Application No.	Applicant(s)	
	10/089,926	KONDO ET AL.	
Notice of Allowability	Examiner	Art Unit	
	Manav Seth	2625	
The MAILING DATE of this communication apperature All claims being allowable, PROSECUTION ON THE MERITS IS herewith (or previously mailed), a Notice of Allowance (PTOL-85) NOTICE OF ALLOWABILITY IS NOT A GRANT OF PATENT RI of the Office or upon petition by the applicant. See 37 CFR 1.313	(OR REMAINS) CLOSED in this app or other appropriate communication IGHTS. This application is subject to	olication. If not include will be mailed in due	ed course. THIS

EXAMINER'S AMENDMENT

Drawings

FIG.1
PRIOR ART

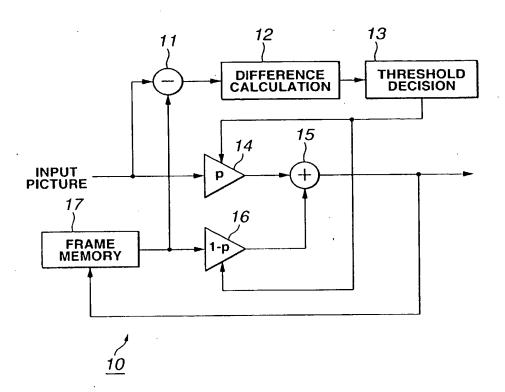
- 2. The following changes to the drawings have been approved by the examiner and agreed upon by applicant:
- (a) Label drawings 1-2, 3A-B, 4A-B, 5-9 as "PRIOR ART".
- (b) Drawing 19: Change the number assigned to the element "Class Code Generation" from 105 to 106. Change the number assigned to the figure from 104 to 105.
- (c) Drawing 22: Change the number assigned to the element "DELAY CIRCUIT" from 165 to 164.
